DATE: July 11, 2025
RE: **Clarendon Hill Thoroughfares Revision Narrative**
FROM: Kendra Halliwell and Tim Synan, ICON Architecture

The total redevelopment of Somerville Housing Authority's Clarendon Hill will include up to 591 new and replacement housing units, common space, public roadways and central park, and the improvement of the intersection at Powderhouse and Alewife Brook Parkway.

CLARENDON HILL
SOMERVILLE, MASSACHUSETTS

G-202

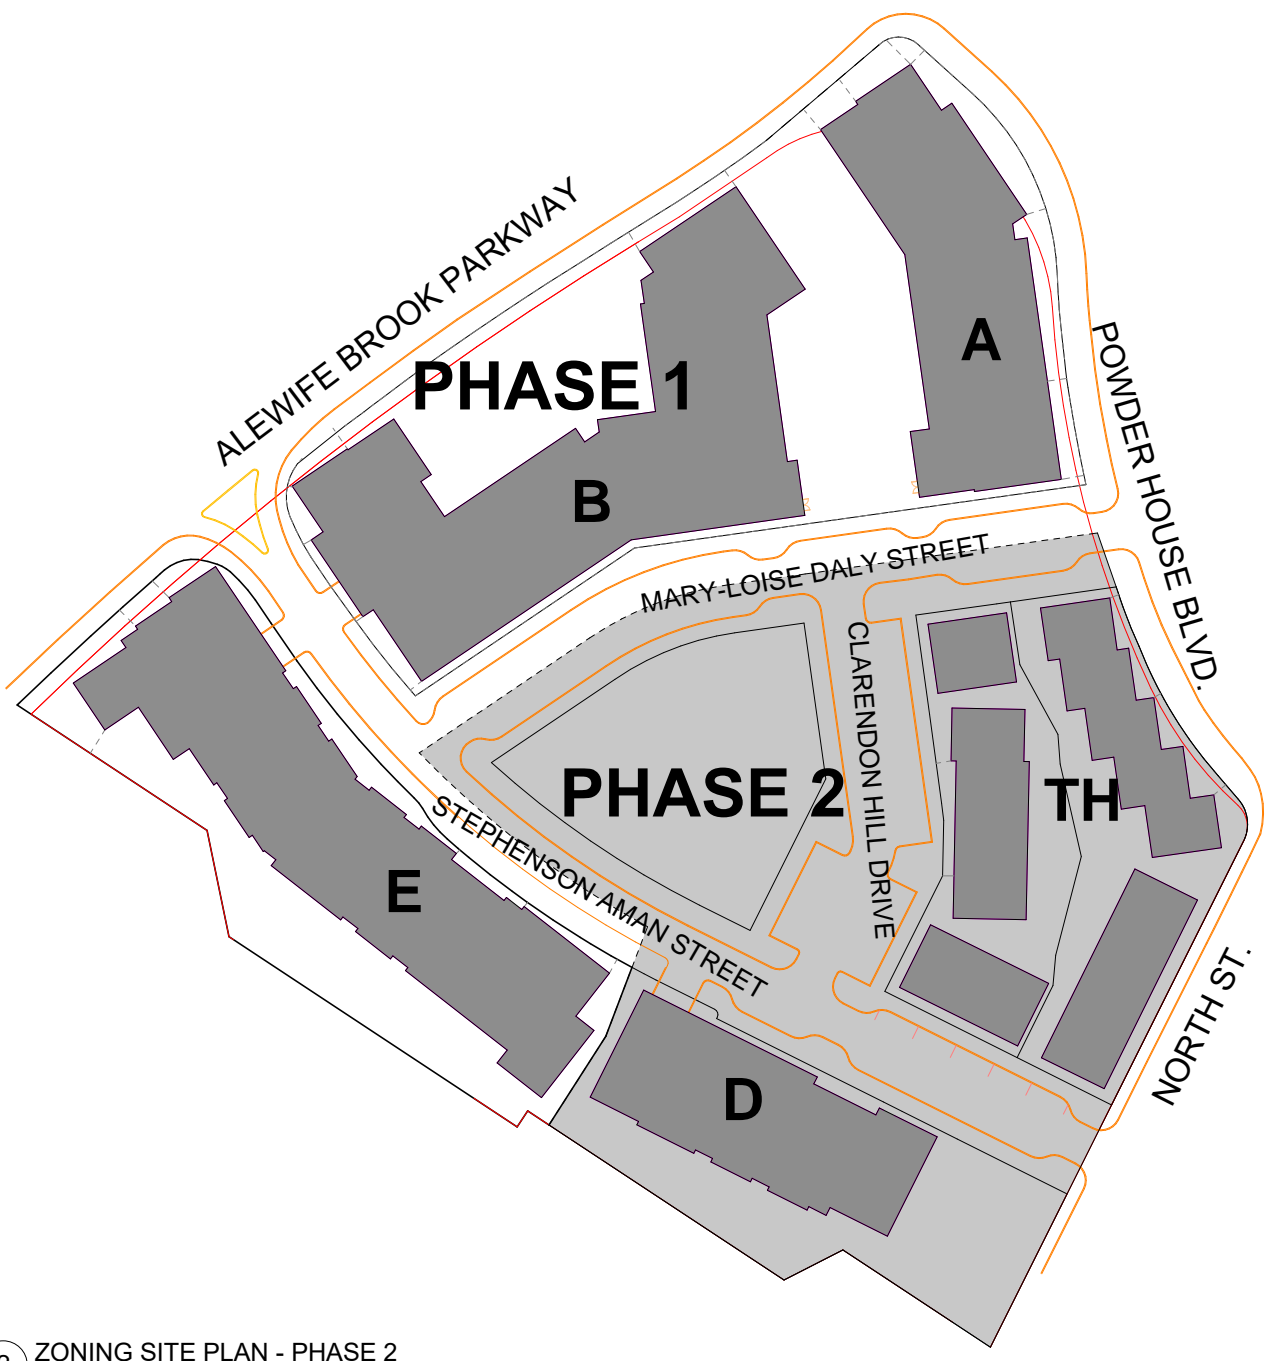
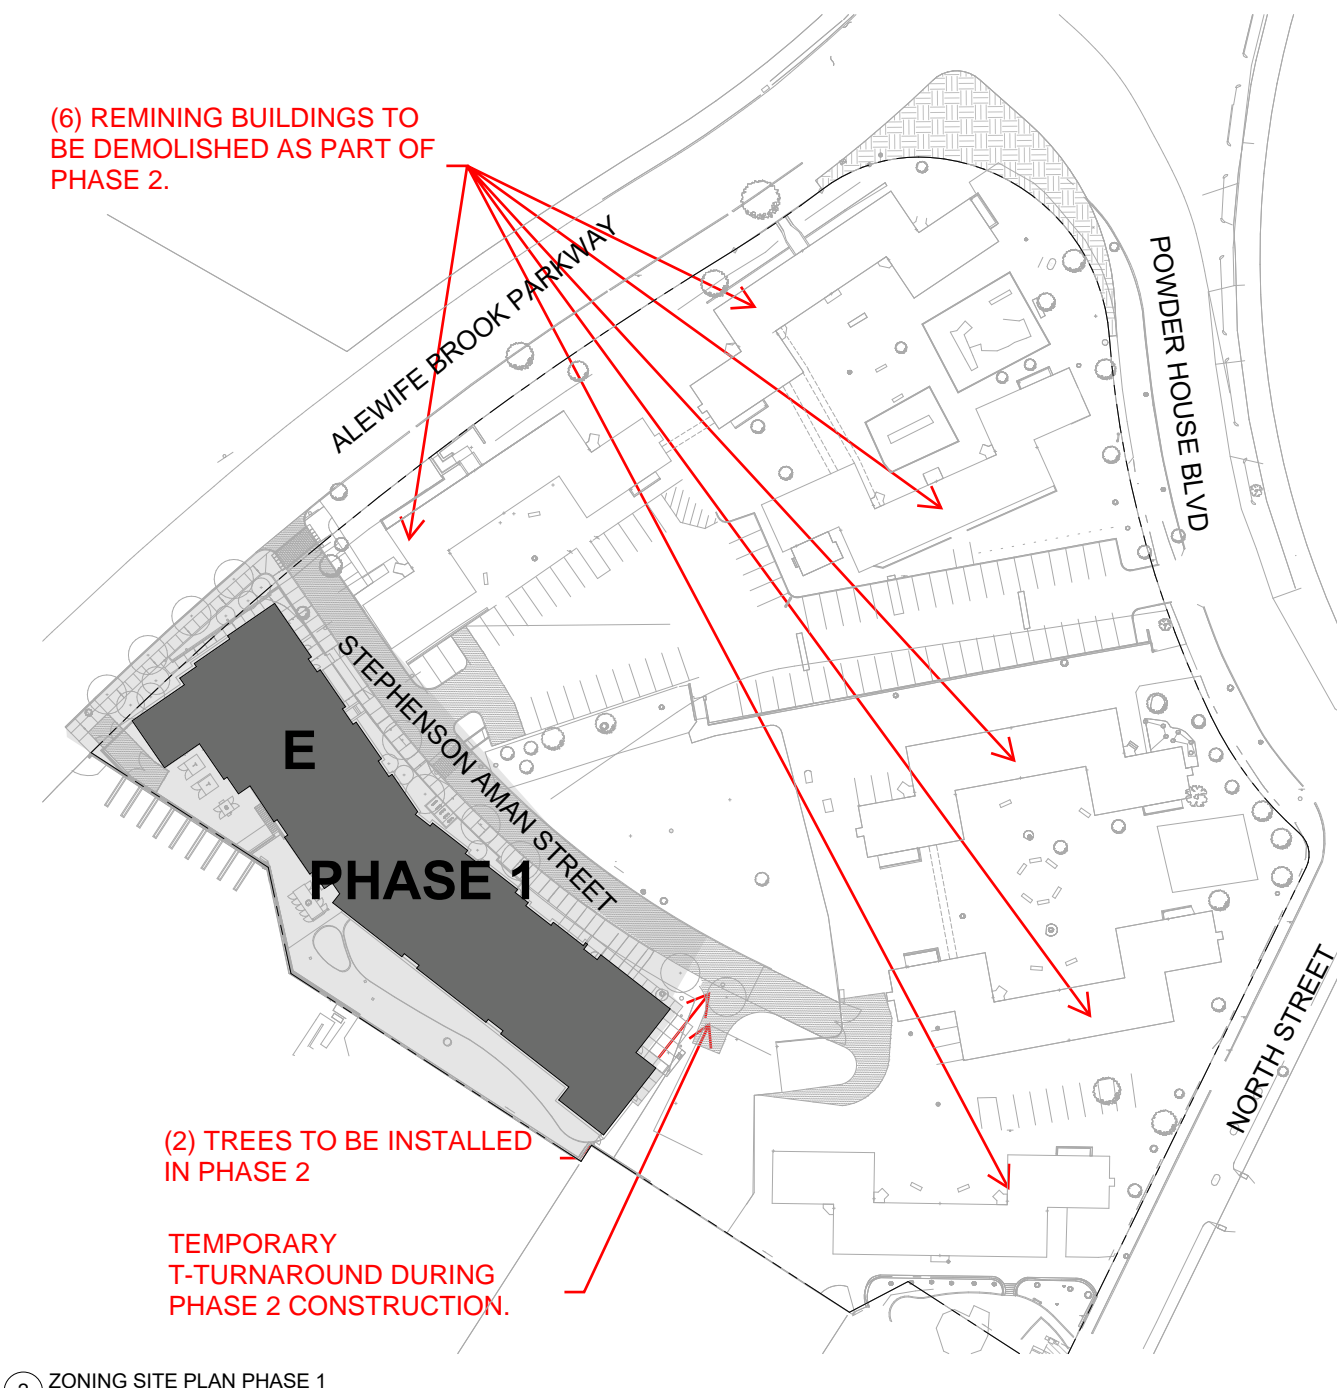
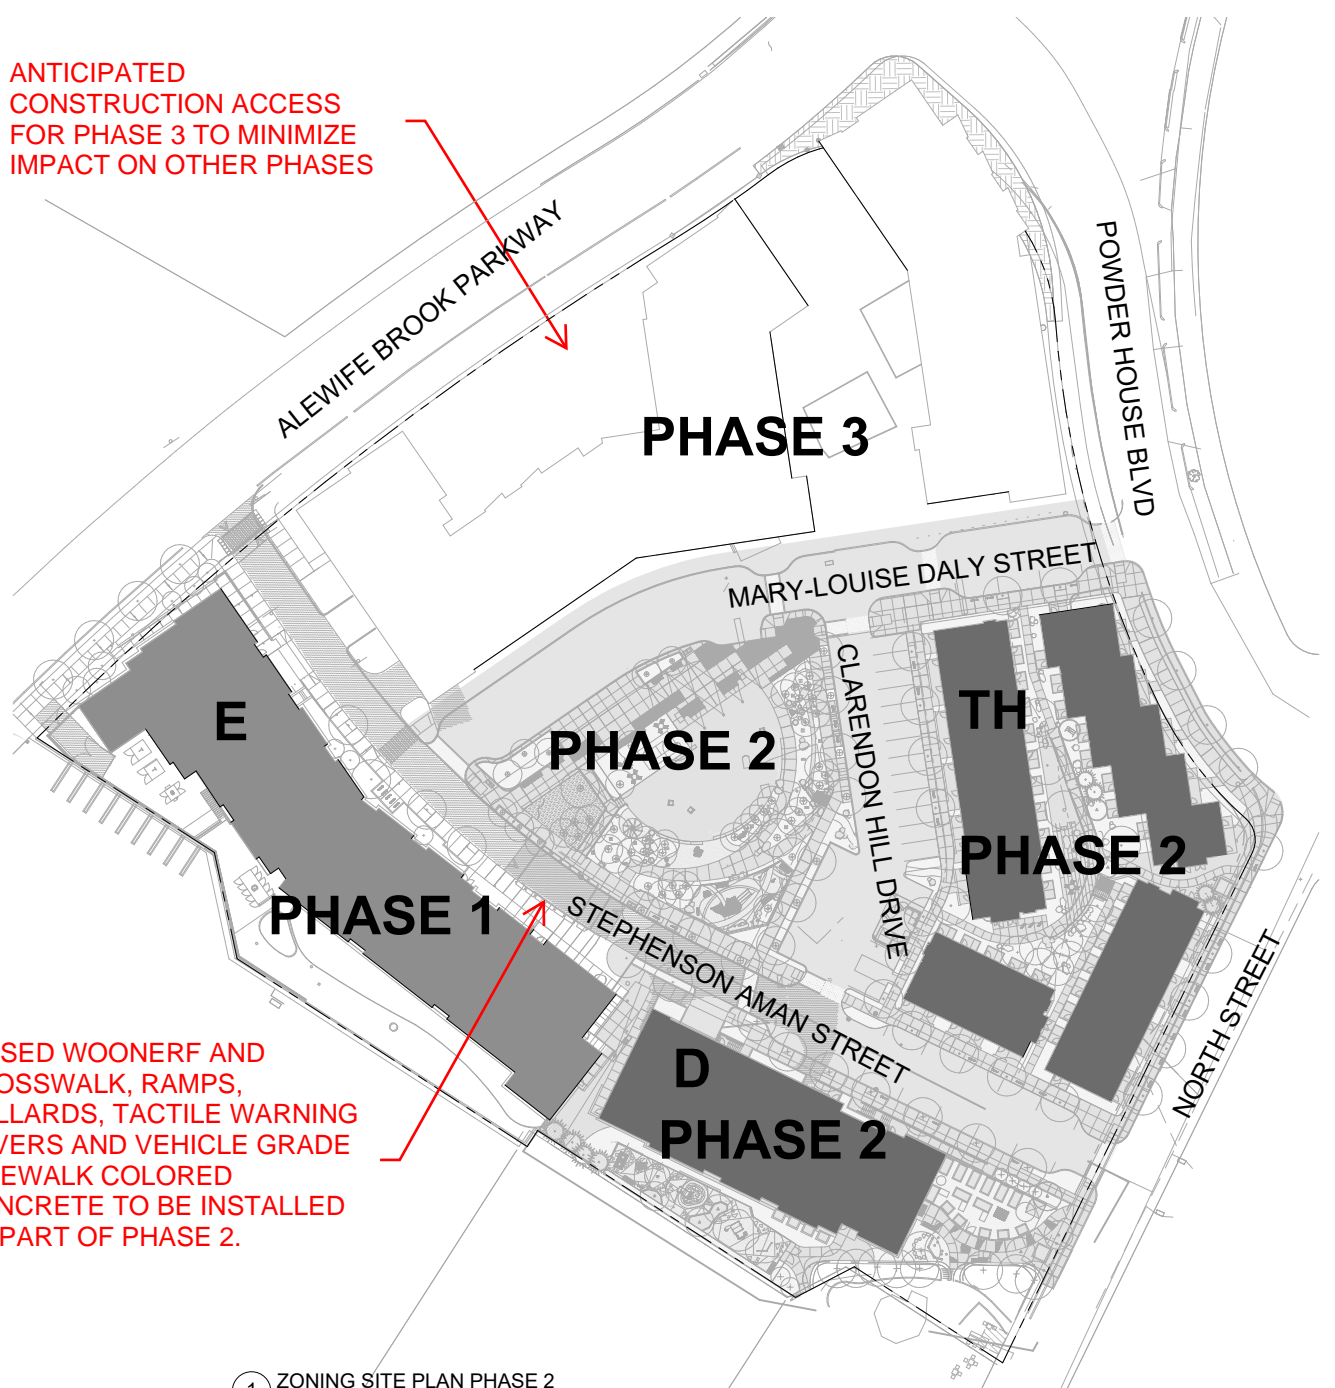
- The zig zag ramp has been removed from the interim condition due to the short transition between phase 1 and 2.
- The raised woonerf and crosswalk, bollards and tactile warning pavers will be constructed/installed in phase 2. Below are the specific items for the phase 2 work related to the woonerf.
 - Raised area with ramped portions on either end.
 - Designated pedestrian crossing.
 - Detectable pavers will be installed on both sides of the woonerf.
 - Woonerf has shifted closer to building entry.
 - Finish material: Temporary asphalt (Phase 1) to be replaced with vehicle grade sidewalk colored concrete (Phase 2).
- The 6 existing buildings on site will be demolished during phase 2.

- Trees near Building D (phase 2) along Stephenson Aman St: These 2 trees will be installed in Phase 2 since the location is where a temporary T-turnaround will be provided while Phase 2 is completed.
